AMENDMENTS TO THE DRAWINGS

AMENDMENT UNDER 37 C.F.R. § 1.111
Application No.: 10/815,723

Attorney Docket No.: Q80623

Fig. 4

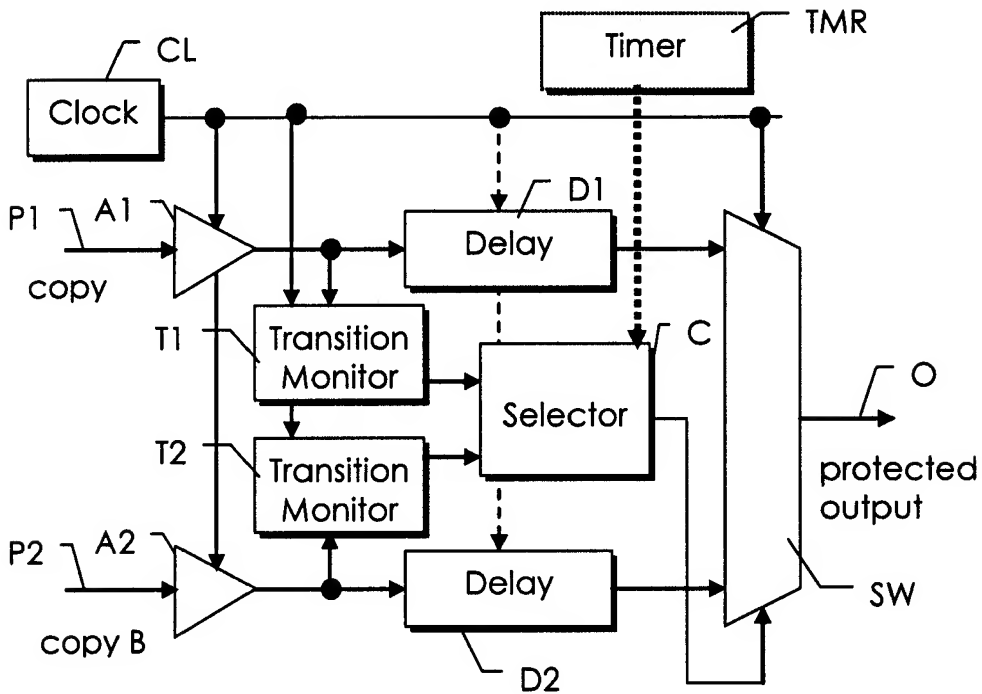
The Examiner has objected to the drawings as allegedly not showing every feature of the invention specified in the claims. In particular, the Examiner alleges that the “timer” claimed in claim 4 must be shown in a drawing, or the feature must be canceled from the claim. Applicants add Figure 4, which includes a “timer” in accordance with the specification and claims. In addition, Applicants amend the specification to describe new Figure 4.

In view of these self-explanatory amendments, Applicants respectfully request the Examiner to withdraw the objection.
